Change Notification Update Polymer Surface Mount to Black Epoxy Resin

AVX has simplified its approach to transitioning Polymer surface mount capacitors from gold to black resin by allowing the continued use of current PNs and managing the change by date only.

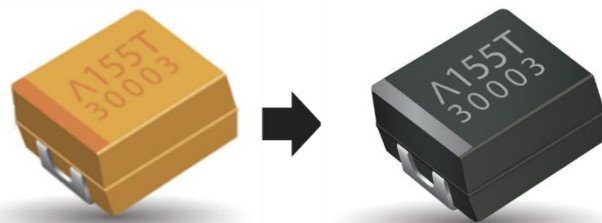
Example:

TCJD337M006R0025 → Gold resin changing to Black before July, 2020

TCJD337M006R0025 → Black only after July, 2020

TCJD337M006R0025E → Black only available now and will continue to be supplied
